Kit Instruction - 39A060B37R 39A060B62R 39A060B71R

Maintenance Bulletin

MAINTENANCE BULLETIN B22MB76002
January 2, 1976

SUBJECT: NEW IMPROVED CHART DRIVE TIMER MOTORS

PARAGON CHART DRIVE MOTOR INSTALLATION

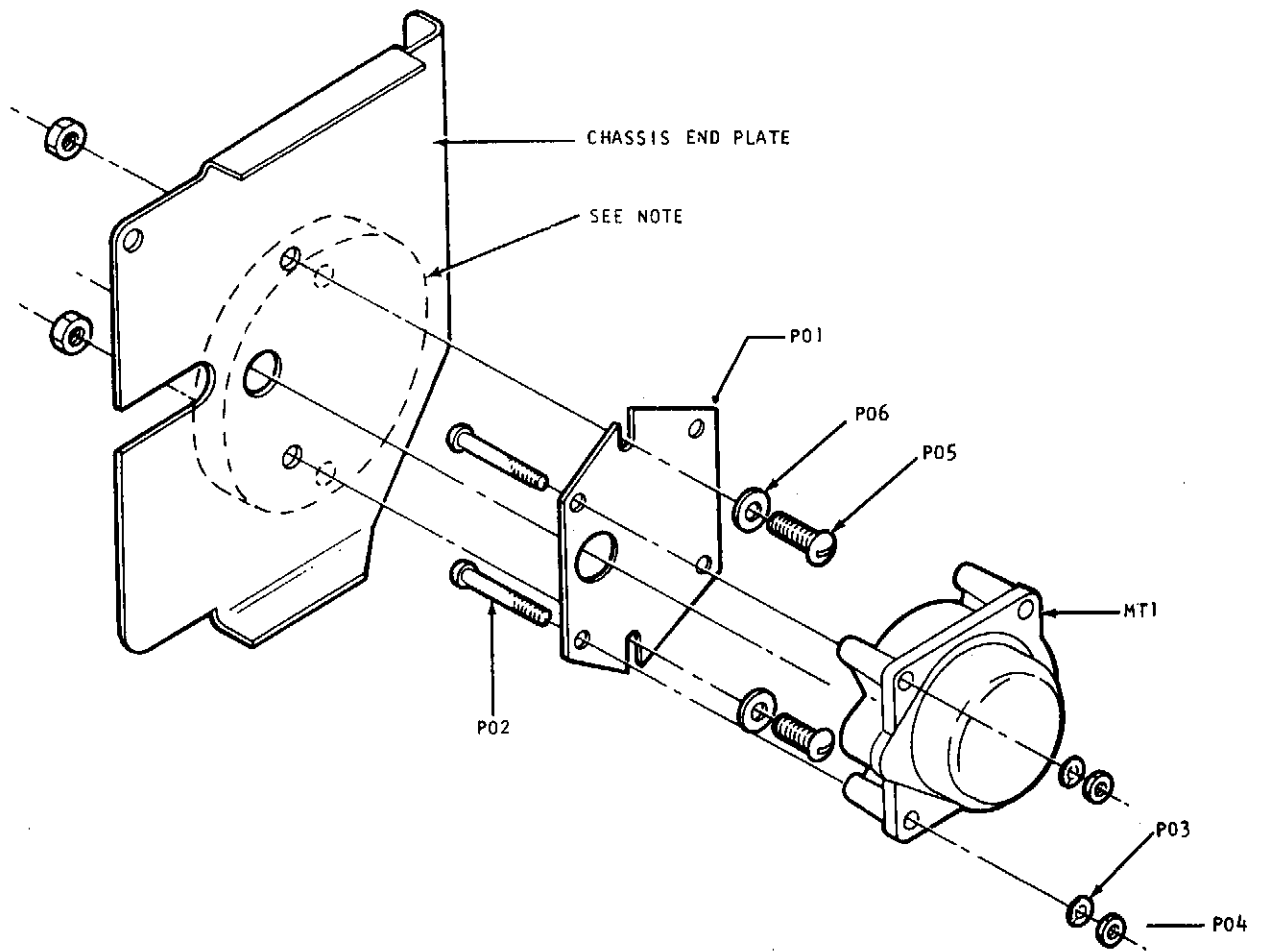
We have just recently begun using a new, improved chart drive motor, which we have thoroughly tested under severe operating conditions and found superior to motors used previously. This new motor has heavier gears and we feel it should prove more durable in operation.

For replacing the old chart drive motor with the new chart drive motor, we furnish the new motor in a kit with the necessary additional parts and instructions. Please refer to the attached page BMP760023 and the reverse side BMP760023R. The drawings and simple instructions show how easy it is to install the new motor in place of the old one. You will notice that each side of the page contains different drawings and instructions dealing with the two possibilities of previously mounted chart drive motors in production. These motors are used on all 88-minute calibrated charts and are available in both 50 and 60 cycles.

1. Disconnect chart drive motor leads and remove attaching hardware (two nuts to be reinstalled later).
2. Attach bracket (P01) onto new motor (MT1) using four screws (P02) lockwashers (P03) and nuts (P04).
3. Mount assembly to chassis end plate using screws (P05) flatwashers (P06) and two nuts previously removed (Step 1). Connect chart drive motor leads.

NOTE: When replacing the old style chart drive motor, the round gear case from the old unit must be completely removed before the new one can be installed.
